AMMONIA ICE RINK PLANT REVIEW

THOROLD COMMUNITY ARENAS

Report Dated: April 2019

Site Review: January 2019

Figure 15 - Ammonia Exposure Levels

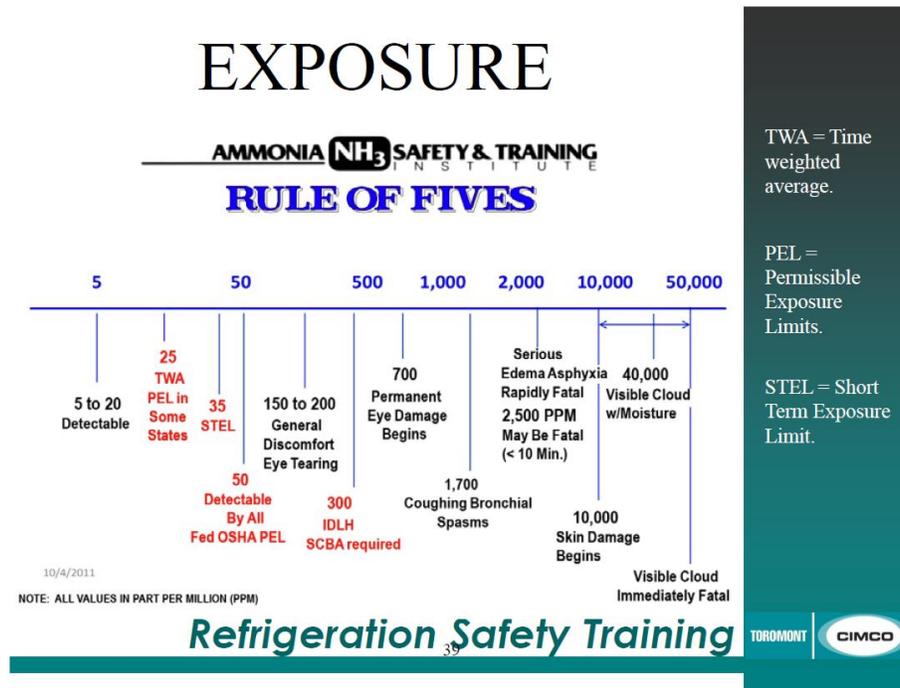
Currently, the only eyewash station in the facility is located in the arena workshop, up two flights of stairs and well away from the machinery room. While it is not explicitly required by CSA B52-13, CIMCO strongly recommends installing an eyewash station inside the machinery room itself as irreversible negative effects of ammonia exposure can occur within 10 seconds if not treated, depending on the quantity of ammonia released. The Immediate Danger to Life and Health (IDLH) concentration for anhydrous ammonia is 300ppm, so contact with even a very small amount of ammonia should be treated as quickly as possible. Typically, the eyewash station is installed in a location that is accessible within 10 seconds of the compressors as this is the most likely location for an emergency ammonia release.

The only accessible eyewash station is serving both the arena workshop area and the machinery room and is too far from potential ammonia exposure hazard locations. A second eyewash station should be installed within the machinery room to serve this area during an emergency situation.
